Re: FortisBC Energy Inc. (FEI)

**Application for a Certificate of Public Convenience and Necessity (CPCN) for
Approval of the Interior Transmission System Transmission Integrity
Management Capabilities Project (Application)**

**Response to the British Columbia Utilities Commission (BCUC) Information
Request (IR) No. 3**

22 **Figure 1: Example Pressure Schematic for Transmission Pipeline**

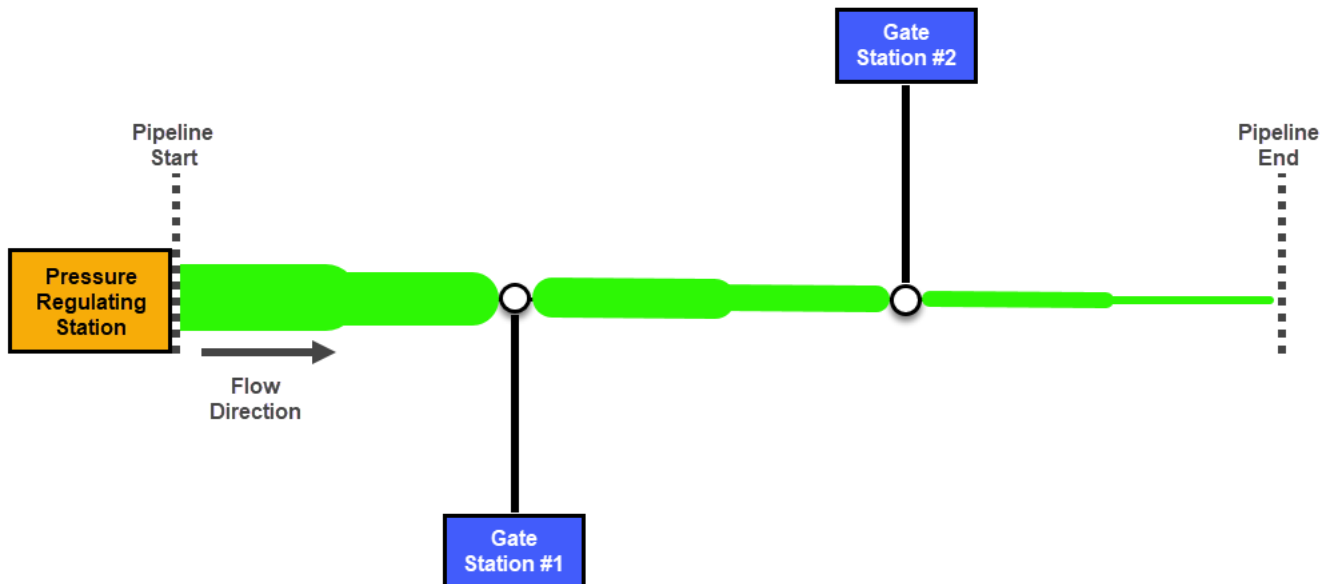
1 29.3 Please confirm, or explain otherwise, that FEI’s ITS transmission pipelines operate
 2 at 80 percent of the established operating pressure at certain times of the year, for
 3 example as a result of seasonal fluctuations in demand.

4 29.3.1 If confirmed, please clarify whether the proposed PRS are only required
 5 should the ILI run occur when the pipeline is operating above 80 percent
 6 of the established operating pressure.

9 Segments of the ITS transmission pipelines may operate at or below 80 percent of the EOP at
 10 certain times of the year.

11 As illustrated in the figure below, a pressure regulating station sets the pressure into the pipeline.
 12 Pressure (represented by the thickness of the green line) at the start of the pipeline is highest
 13 following the pressure regulating station and reduces over the length of the pipeline due to friction
 14 and other factors.

15 Under normal operating conditions, the pressure at the start of the pipeline would typically be
 16 expected to be at or near its full operating pressure (i.e., typically referred to as maximum
 17 operating pressure or MOP, which is higher than 80 percent of the EOP), with a pressure
 18 degradation profile that reaches 80 percent of EOP at a certain point along the line. As the
 19 pressure regulating station is not set to restrict pressure (e.g., to 80 percent of EOP), pressure in
 20 the pipeline can change quickly and over time (e.g., system upsets, demand changes) up to its
 21 full operating pressure (i.e., to exceed 80 percent of EOP).

15 FEI requires the proposed PRS at the Yahk Station to ensure that pressure on the YAH TRA 323
16 does not exceed 80 percent of the EOP anywhere on the pipeline, regardless of whether
17 segments of the pipeline may be operating at or below 80 percent of the EOP at the time when
18 the need for a pressure reduction is identified.

Figure 2: Simplified Schematic of the YAH TRA 323 Transmission Pipeline

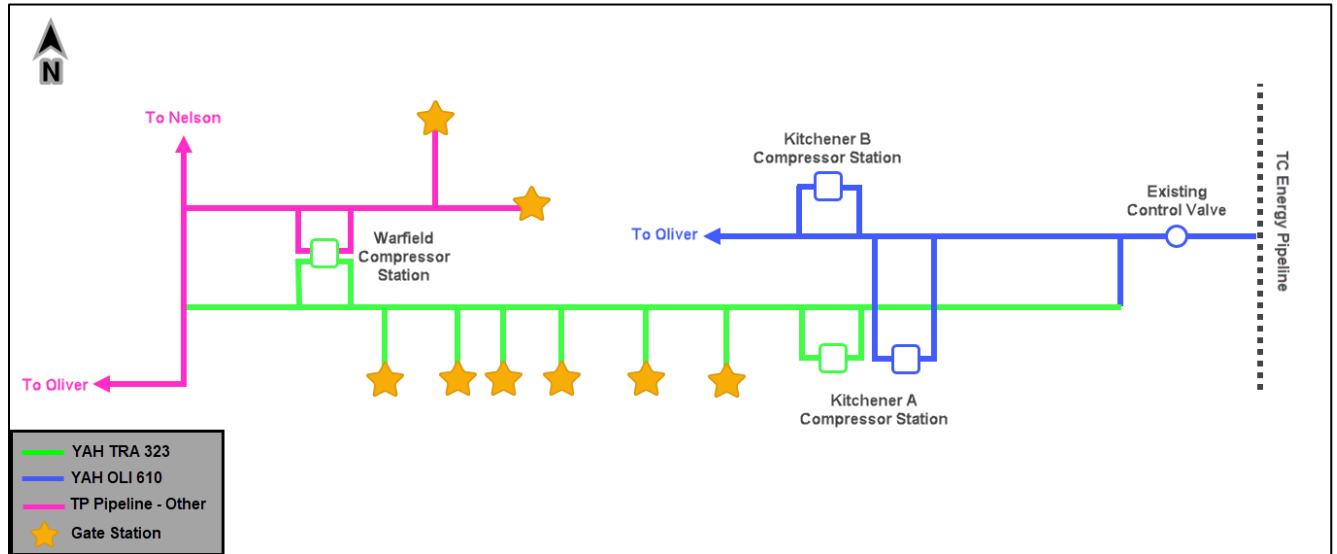
1
2 29.4.1 Please explain whether FEI anticipates that the operating pressure of the
3 YAH TRA 323 pipeline will be 80 percent of the pipeline's current
4 established operating pressure by the date of the initial EMAT ILI run, for
5 example due to reduction in demand or system reconfiguration. Please
6 discuss the continued need for the PRS under this scenario.

9 FEI does not anticipate that the operating pressure of the YAH TRA 323 pipeline will be at or
10 below 80 percent of the pipeline's current established operating pressure by the date of the initial
11 EMAT ILI run for the reasons outlined below. As such, for the reasons outlined in the response to
12 BCUC IR3 29.3, there is a continued need for a PRS at the Yahk Station.

20 Second, the YAH TRA 323 pipeline has a maximum operating pressure of 7,136 kPa and can
21 flow gas bi-directionally. For most of the year, FEI flows gas east to west, receiving gas from TC
22 Energy at a minimum contractual delivery pressure of 5,171 kPa and feeding communities as far
23 west as Osoyoos, depending on the time of year. When required, the gas pressure may be
24 increased up to the maximum operating pressure of 7,136 kPa at the Kitchener A Compressor
25 Station to ensure sufficient inlet pressure to tail-end gate stations. As such, the only way the
26 entirety of the YAH TRA 323 pipeline could be operating at or below 80 percent of the pipeline's
27 current established operating pressure is if FEI sets the existing control valve to limit the inlet
28 pressure to the YAH TRA 323 and YAH OLI 610 pipelines to 80 percent of the EOP of the YAH
29 TRA 323 pipeline. Under this operating scenario, the Kitchener and Warfield Compressor Stations

30 would need to operate more frequently and with higher horsepower utilization, resulting in higher
31 O&M costs (comprised of fuel costs and carbon taxes). Further, as discussed in A12 of FEI's
32 Rebuttal Evidence, this unnecessary pressure restriction on the YAH OLI 610 pipeline would limit
33 FEI's ability to supply the maximum load of 105 MMSCFD at Kingsvale and down to the CTS on
34 colder days, resulting in higher gas costs to secure the balance of supply for the CTS in the open
35 market. These incremental gas costs would be similar to those provided in A16 of FEI's Rebuttal
36 Evidence under the discussion of Events 29 and 31. Please refer to the figure below which
37 provides a simplified schematic of the YAH TRA 323 pipeline.
